DNR Project No. DC-0190

Subject: Amendment Request – Village of Cross Plains / Town of Berry CARPC Resolution DC-2017-14

Resolution CARPC No. 2017-14

**Recommending to the Wisconsin Department of Natural Resources Amendment of the
Dane County Water Quality Management Plan by Revising the
Cross Plains Sewer Service Area Boundary and Environmental Corridors
in the Town of Berry and the Village of Cross Plains**

Map 1 Amendment Area

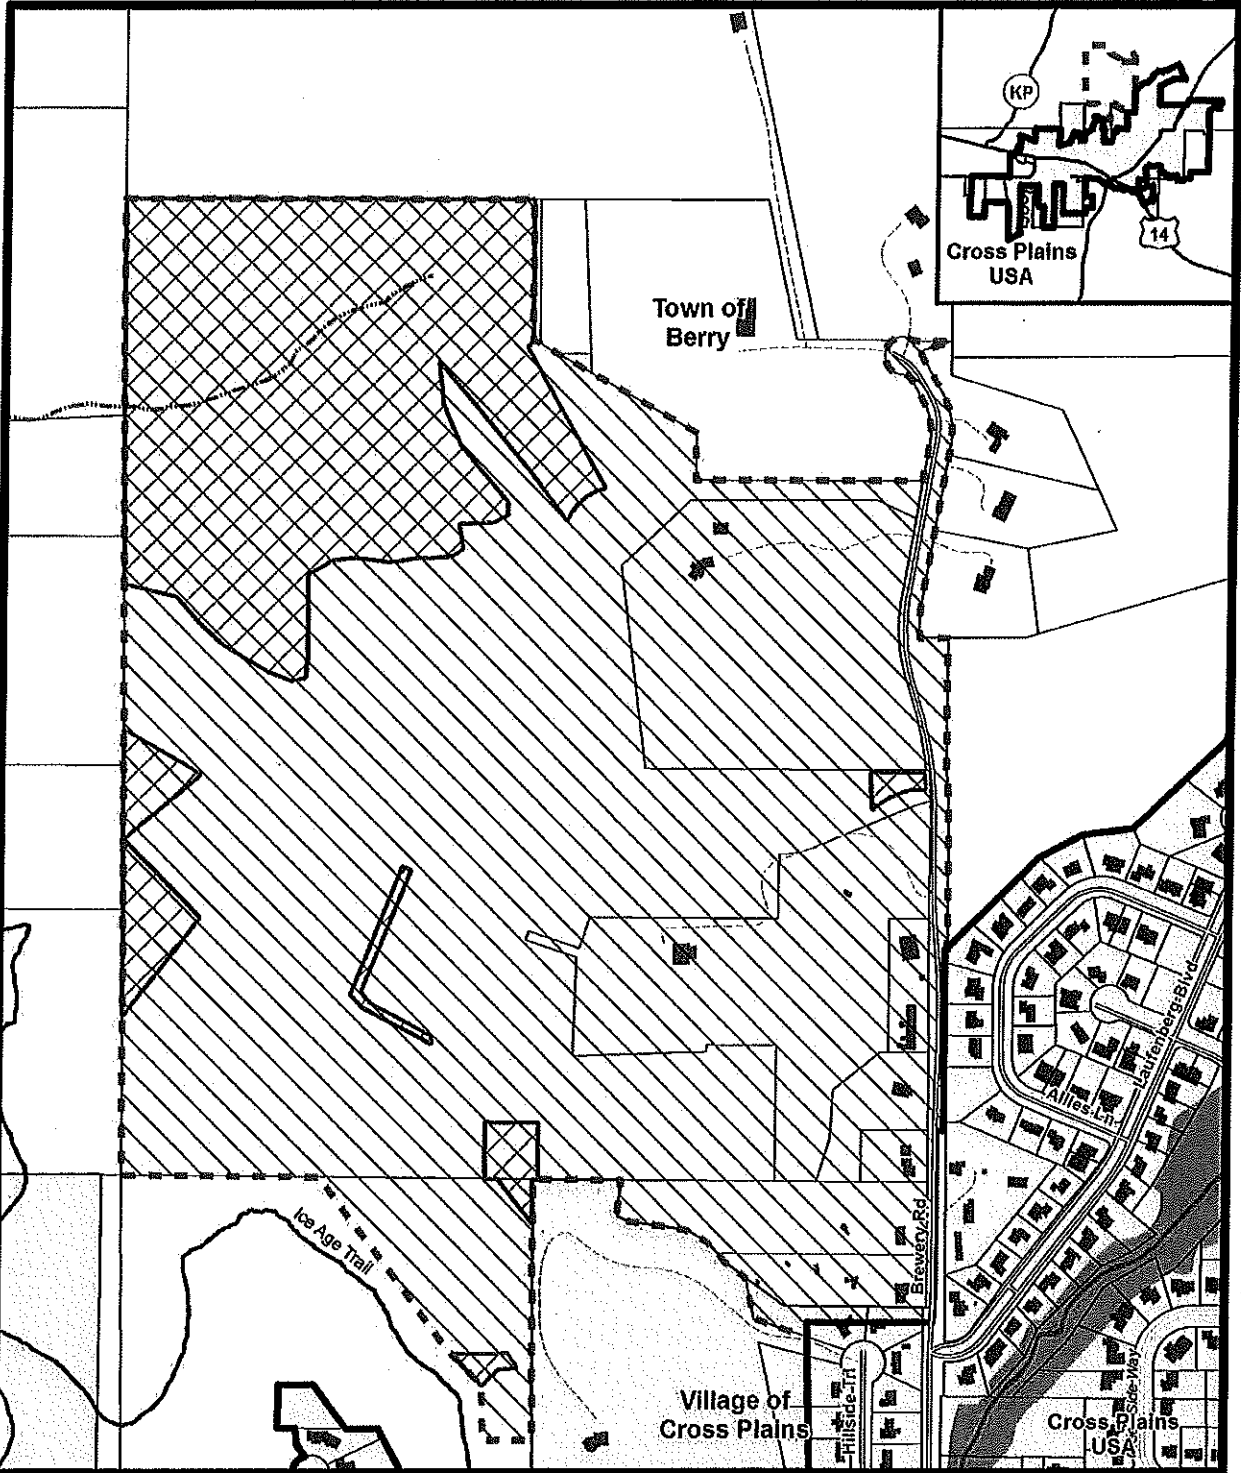
NOW, THEREFORE, BE IT RESOLVED that in accordance with Wis. Stat. § 66.0309, and Sec. 208 of Public Law 92-500, the Capital Area Regional Planning Commission recommends the amendment of the *Dane County Water Quality Management Plan* by revising the Cross Plains Sewer Service Area boundaries as shown on the attached map.

The recommendation for approval of this amendment is based on the Village of Cross Plains submitted proposal and conditioned on the Village's continued commitment to pursuing the following:

4. Delineate environmental corridors to include the intermittent stream, associated buffers, and riparian steep wooded slopes, and stormwater management areas to meet Dane County Water Quality Plan criteria for the delineation of environmental corridors. Submit plats showing environmental corridors for Regional Planning Commission staff review and approval prior to recording. Any environmental corridor on private property shall be protected by deed restrictions and neighborhood covenants.
